From: BRYAN Martin (EXT) [Martin.Bryan.ext@areva.com]
Sent: Monday, June 14, 2010 4:44 PM
To: Tesfaye, Getachew
Cc: KOWALSKI David J (AREVA NP INC); ROMINE Judy (AREVA NP INC); WILLIFORD Dennis C (AREVA NP INC)
Subject: FW: DRAFT RESPONSES FOR FSAR Chapter 9 Weekly NRC Telecon
Attachments: Blank Bkgrd.gif; RESPONSE RAI 406 Q 09 02 02-110-Draft.pdf; RESPONSE RAI 345 Supp 1 Q 09 02 01-26-Draft.pdf; RESPONSE RAI 345 Supp 1 Q 09 02 01-27-Draft.pdf; RESPONSE RAI 345 Supp 1 Q 09 02 01-30 (f)-Draft.pdf; RESPONSE RAI 345 Supp 1 Q 09 02 01-38 (c)-Draft.pdf; RESPONSE RAI 345 Supp 1 Q 09 02 01-43-Draft.pdf; RESPONSE RAI 406 Q 09 02 02-109-Draft.pdf

From: KOWALSKI David J (AREVA NP INC)
Sent: Monday, June 14, 2010 3:59 PM
To: BRYAN Martin (EXT)
Cc: GARDNER George Darrell (AREVA NP INC); BALLARD Robert W (AREVA NP INC); CONNELL Kevin J (AREVA NP INC); HUDDLESTON Stephen C (AREVA NP INC); HARTSELL Jody M (AREVA NP INC); BROUGHTON JR Ronnie T (AREVA NP INC); SLOAN Sandra M (AREVA NP INC); MCINTYRE Brian (AREVA NP INC)
Subject: DRAFT RESPONSES FOR FSAR Chapter 9 Weekly NRC Telecon
Importance: High

Request for Additional Information No. 406(4683, 4664, 4707), Revision 0

U. S. EPR Standard Design

Figure 9.2.1-1—Essential Service Water System Piping & Instrumentation Diagram
Sheet 1 of 4

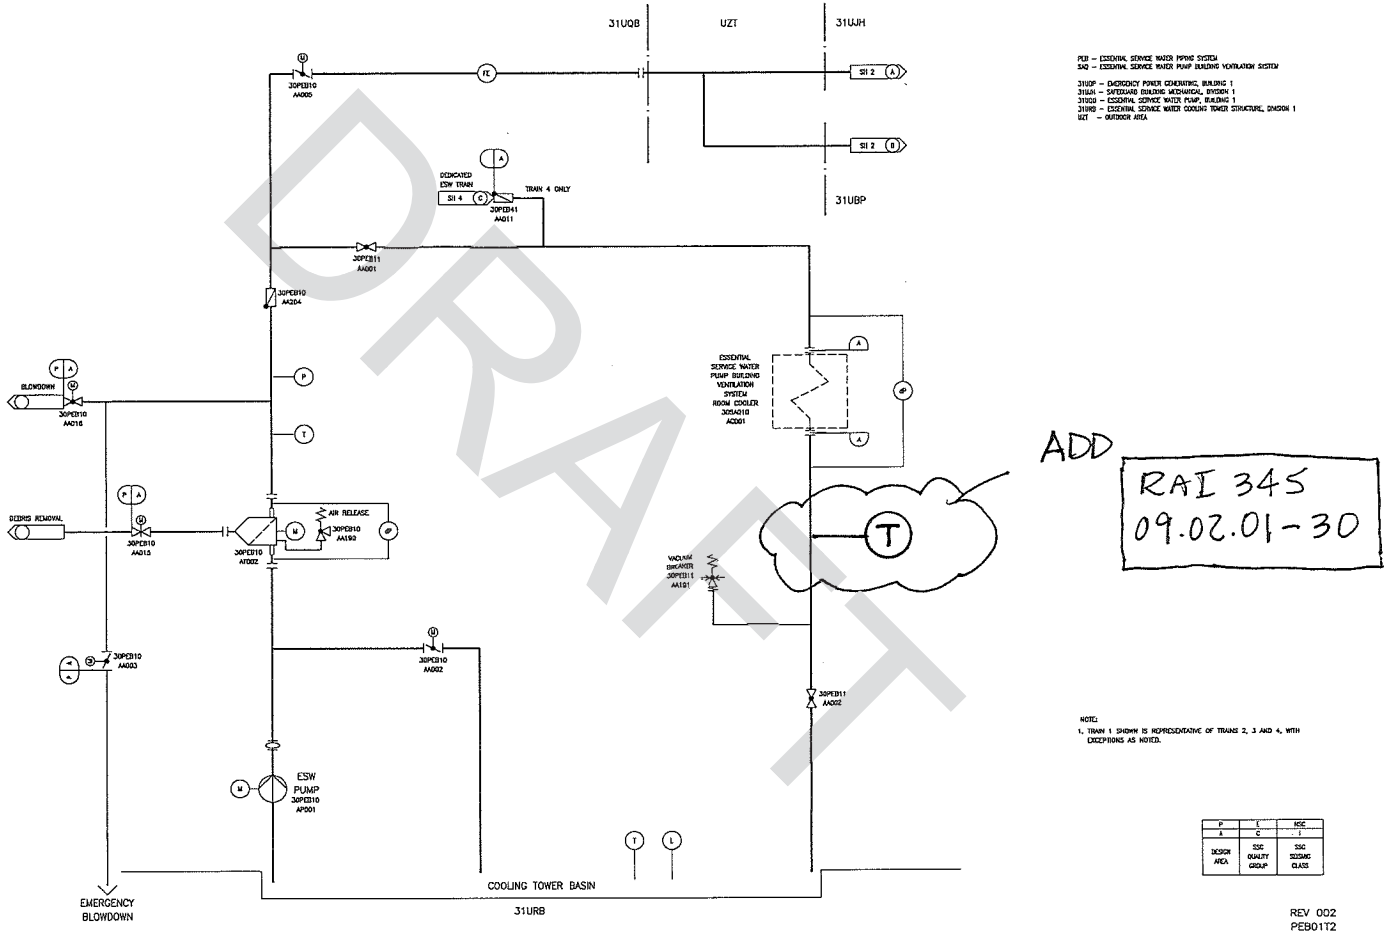
> Part (f)- The P&ID does not show a flow indicator for the ESWS pump room coolers and additional discussion is needed to explain how the ESWS flow rate through the pump room coolers will be periodically verified and confirmed to be adequate.

> The staff reviewed the applicant's response to part (f) of RAI-response 9.2.1-04 above relative to means of periodic confirmation of the adequacy of ESW pump room cooler flow. In this response, the applicant stated that temporary flow instrumentation will be installed for the performance of periodic cooler surveillance testing and testing after repairs. The staff found this response to be unacceptable since plant operators will not have valuable information related to ESWS possible degraded flow rates or degraded heat exchanger performance. This instrumentation should be described in the FSAR.

Indication of the ESW pump building room temperature is provided in the MCR as listed in Tier 1, Table 2.6.13-2. ESW temperature measurement is provided at the discharge of the ESWS pump and will be added downstream of the pump building ventilation system room cooler. Differential pressure across the cooler and temperature indications are available in the control room; therefore, plant operators will have information related to possible ESW degraded flow rates or degraded heat exchanger performance. The differential pressure is also available locally.

Indication of temperature measurement downstream of the pump building ventilation system room cooler will be added to U.S. EPR FSAR Tier 2, Figure 9.2.1-1. New instrumentation will be added to U.S. EPR FSAR Tier 2 Tables 3.10-1 and 3.11-1.

Figure 9.2.2-1—Component Cooling Water System Trains 1 through 4
Sheet 1 of 2

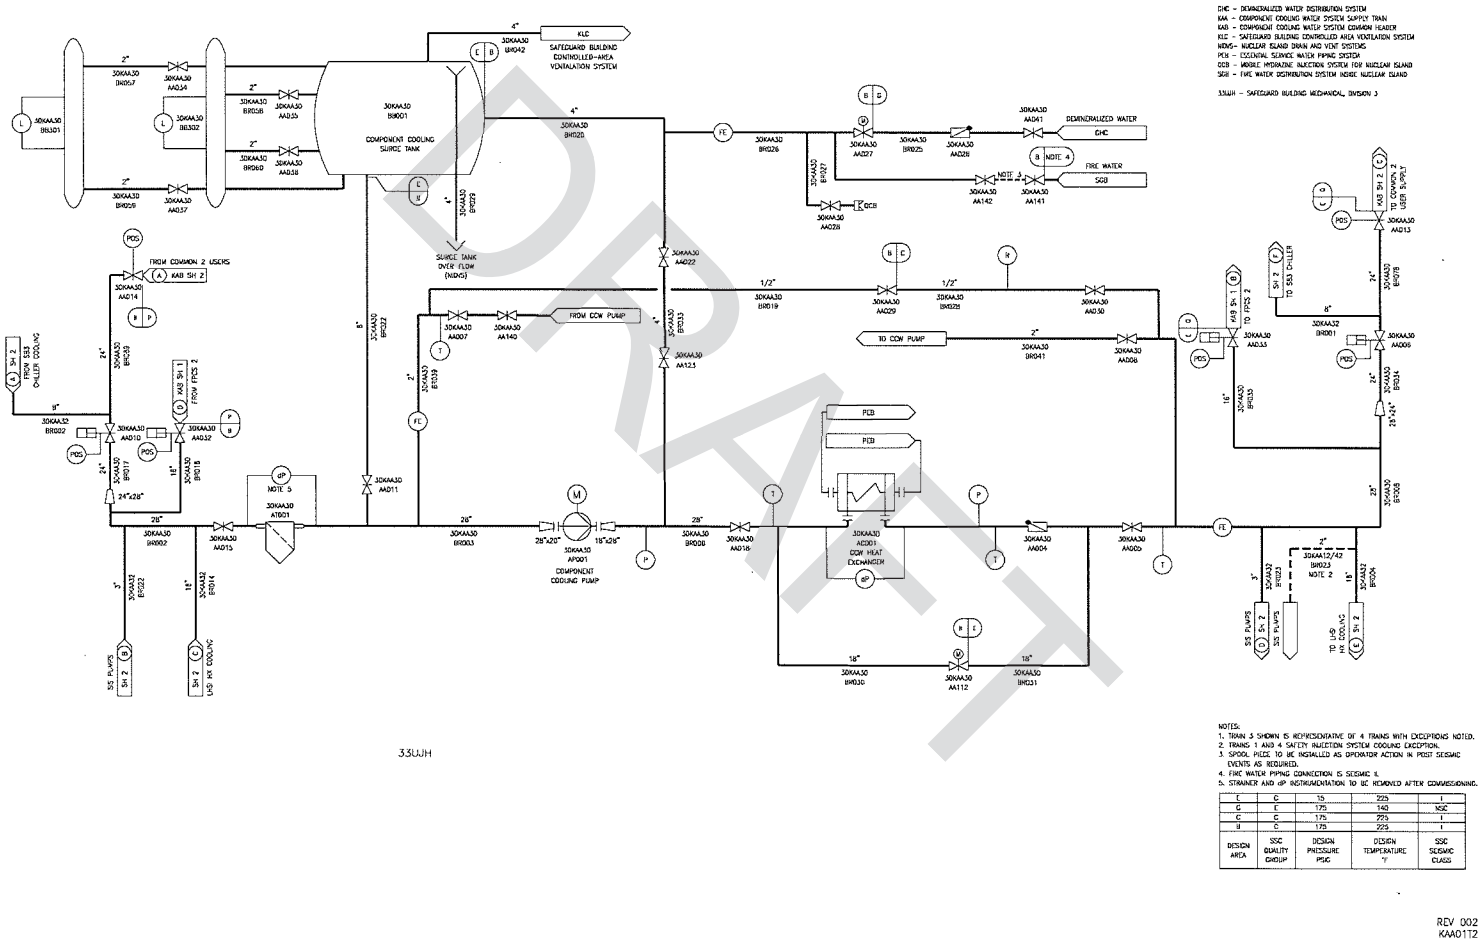
Part (1): In the response to RAI 9.2.2-61 Part 1, the applicant noted that pipe sizes were identified on FSAR Tier 2, P&IDs Figures 9.2.2-1, 2, 3 and 4. While this response is acceptable, the staff noted that some pipe sizes were still missing from Figure 9.2.2-1 for: (1) normal surge tank makeup demineralized water and (2) emergency surge tank makeup water.

Part (1): Normal surge tank makeup from Demineralized Water is through a 2" line. Refer to the Response to RAI 406, 9.2.2-112 for the discussion related to the removal of the emergency post-seismic makeup line.

U.S. EPR FSAR, Tier 2, Figure 9.2.2-1, Tier 2 Section 9.2.2, Tier 1 Section 2.7.1, Tier 1 Table 2.7.1-3 and Tier 1 Figure 2.7.1-1 will be revised as described in the response and indicated on the enclosed markup.

Figure 2.7.1-1—Component Cooling Water System Functional Arrangement
Sheet 7 of 11

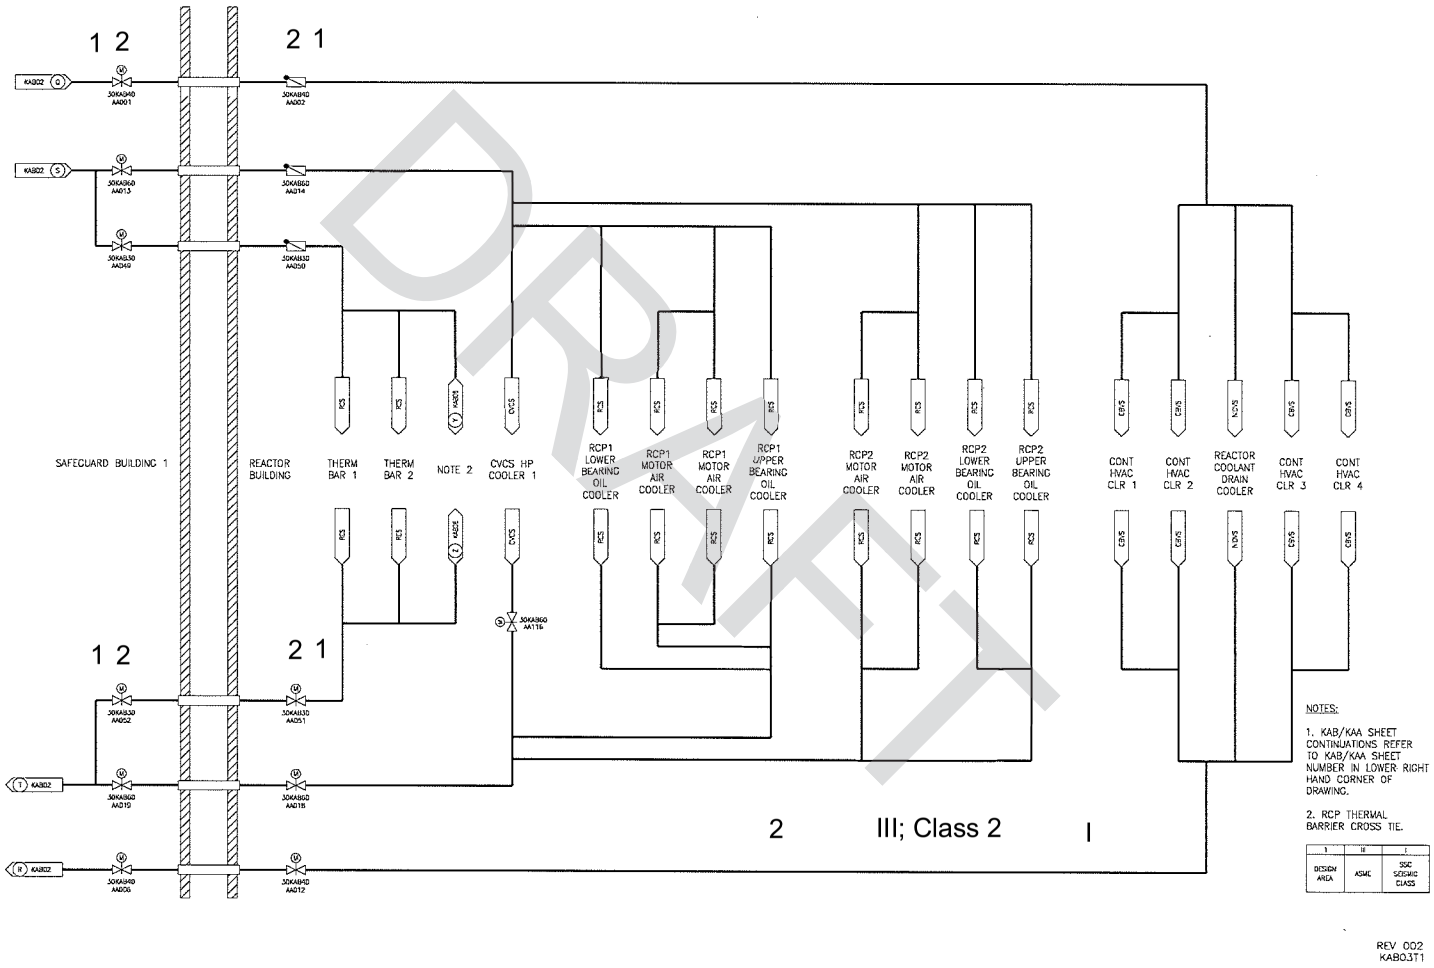
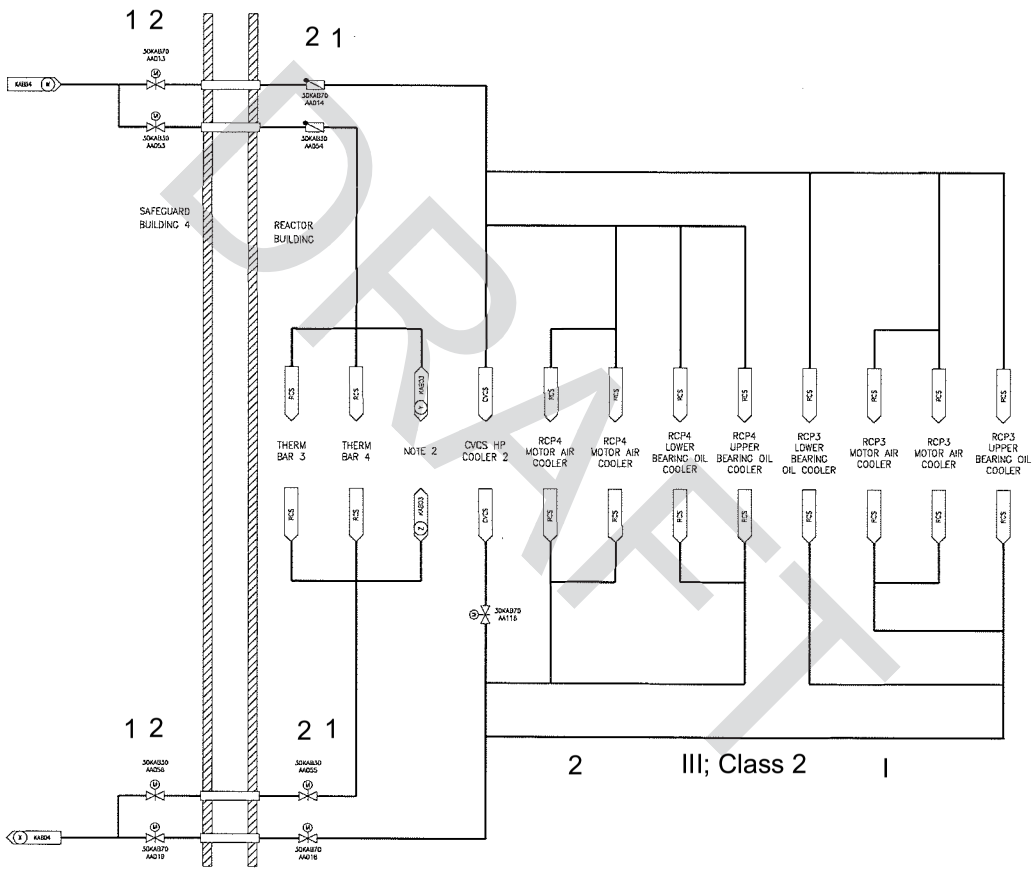
Part 6: In Part 6 the applicant was asked to simplify the 24 page CCWS functional arrangement drawing in Tier 1 (Figure 2.7.1-1). Accordingly the applicant provided a simplified version (11 pages) of Figure 2.7.1-1. The staff found the revised drawings were acceptable but noted that pipe transitions between ASME Class 2 and Class 3 need to be added as appropriate for the CCWS containment penetrations. This is based on SRP 14.3, Appendix C, page 14.3-35, “Figure Check List”. The applicant needs to correct the Tier 1 FSAR markup accordingly.
